Reference: (1) Enrico Fermi Atomic Power Plant, Unit 2  
NRC Docket No. 50-341  
(2) Letter, Detroit Edison to NRC, EF2-63925,  
"Submittal of Plant Unique Analysis Report  
for Torus Attached Piping", June 10, 1983

Subject: Mark I Containment - Torus Attached Piping  
Submittal of Additional Information

Item 1: AAP PUAR Section 2.2.1, AC Section 2.14.3 & 2.14.4

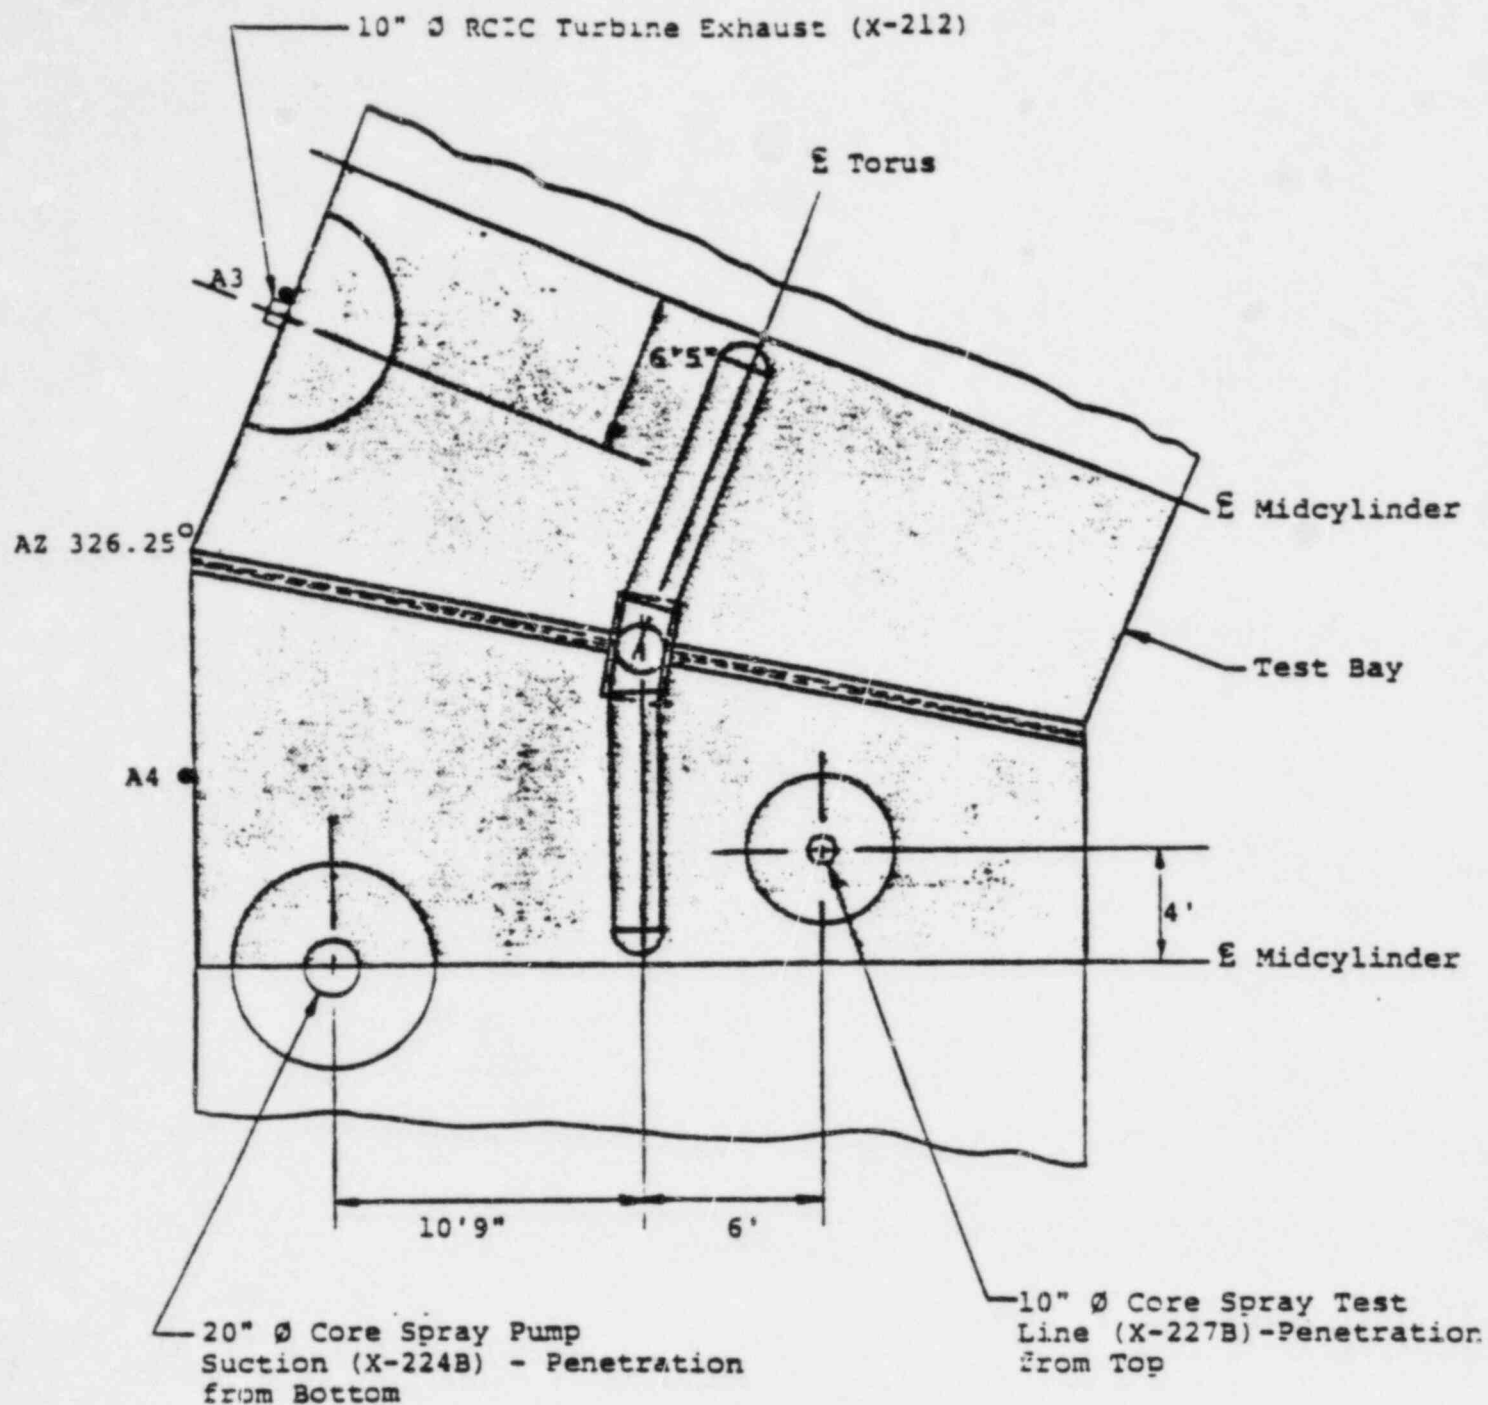
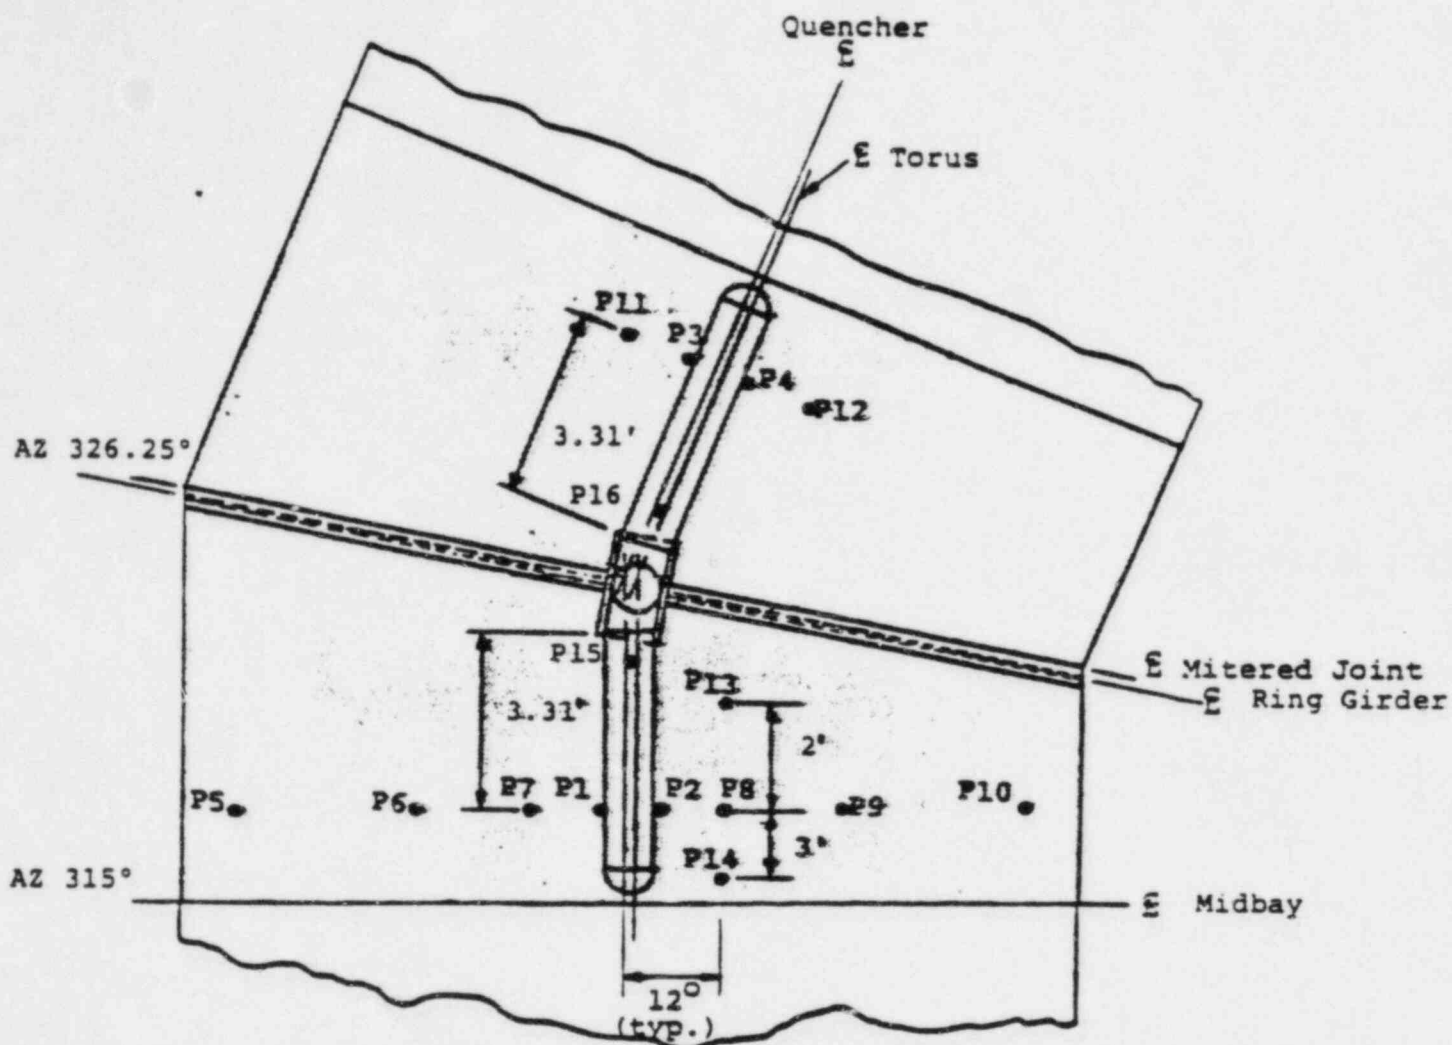
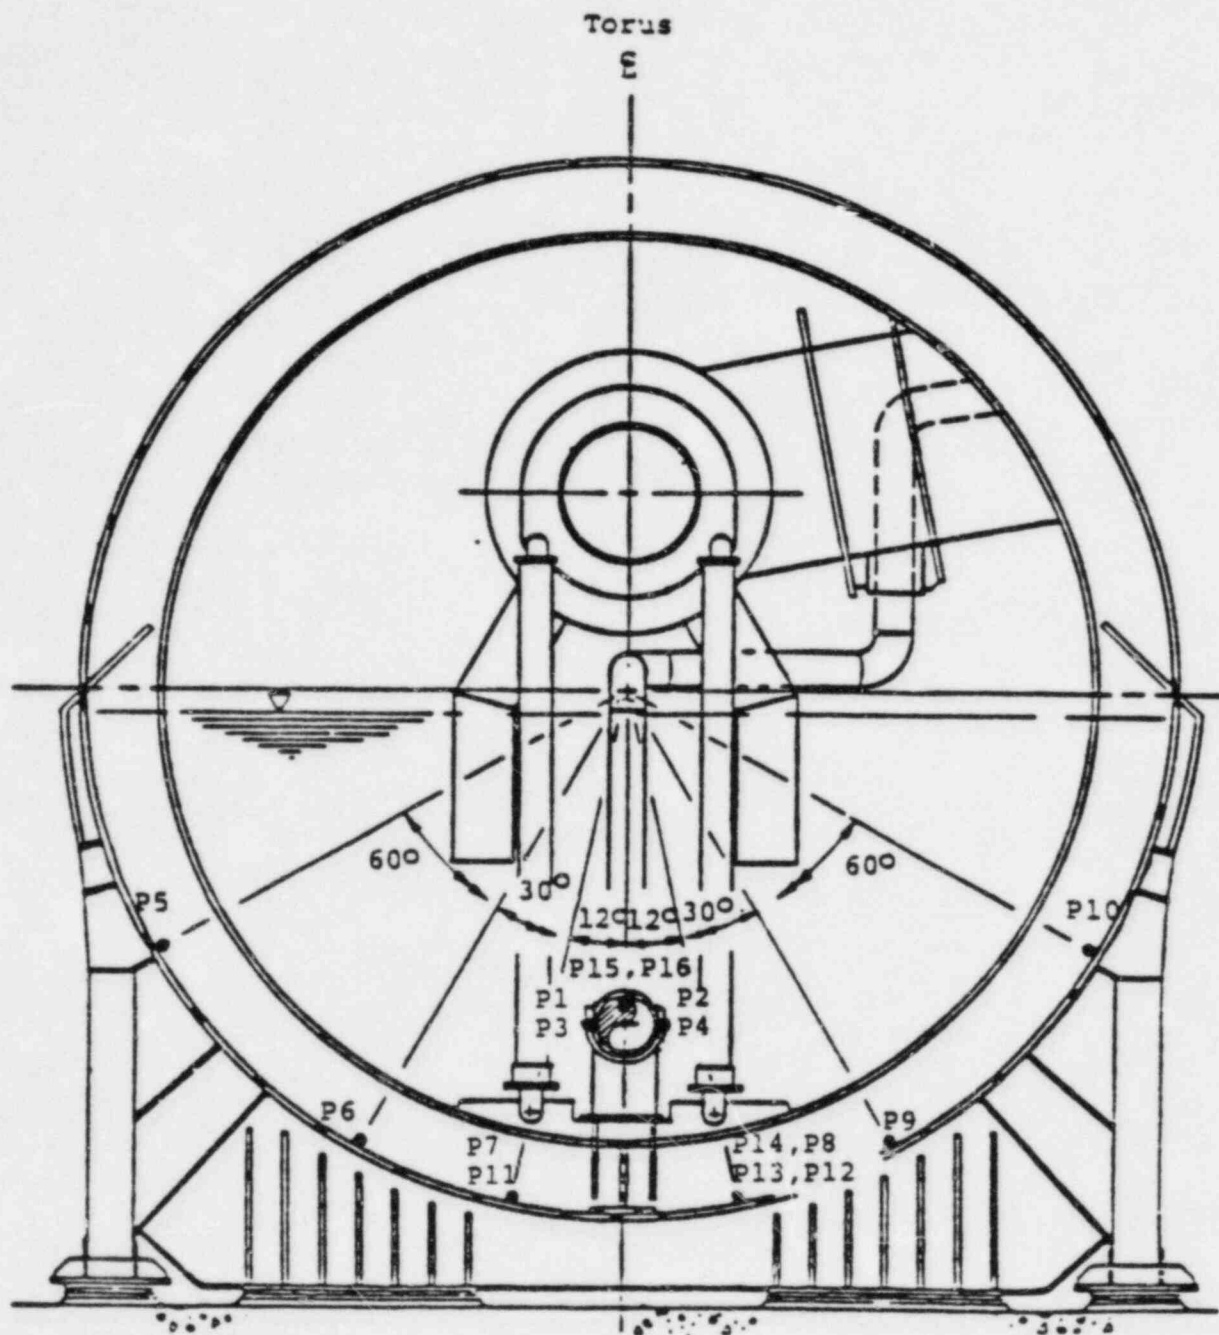
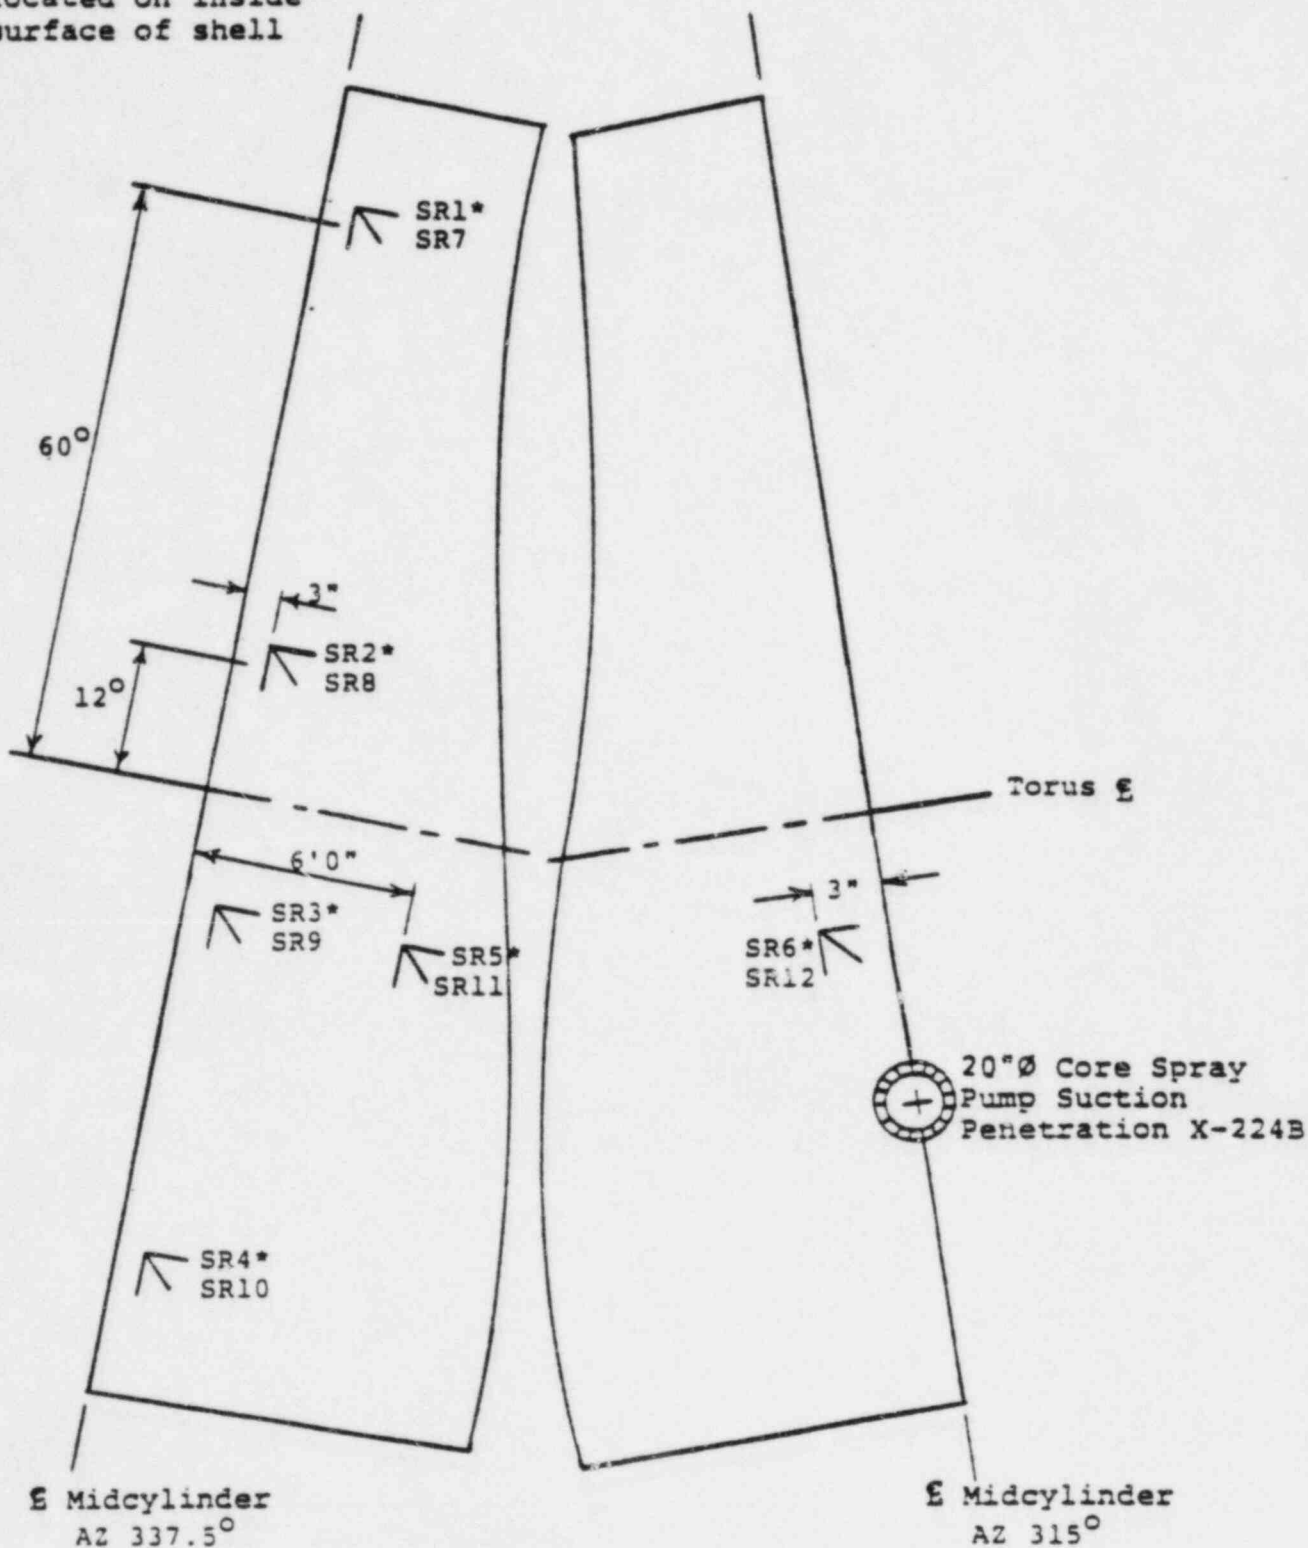
Justify the use of the 0.8 factor used to reduce water jet impingement and air bubble drag loads. The factor previously approved for SRV Torus net vertical forces can be viewed as a ratio of the average pressure on the torus shell to a peak measured pressure and thus, was approved for torus support modifications. However, the use of a reduction factor cannot be accepted, in general, for any TAP analyses independently of the location with respect to the quencher.

Provide sufficient information (include various test data) to illustrate how the factor was arrived at and how its use still provides for a conservative load specification.

The type of instruments used in the Fermi 2 SRV test include pressure transducers, strain rosettes, uniaxial strain gauges and accelerometers. The test instrumentation will require approximately 125 recording channels with a maximum frequency response of 200 Hz. The applicable instrumentation and instrument locations that will be used to measure parameters and response to confirm the SRV load specification applied in the torus attached piping evaluations are shown in Figures 1-1 through 1-4. As shown in Figure 1-1, the instrumented locations also include penetration X-212. The 0.8 reduction factor was applied in the penetration analysis and the analysis of selected components in the line attached to the penetration X-212. The measured response of penetration X-212 will be representative of other penetration locations.
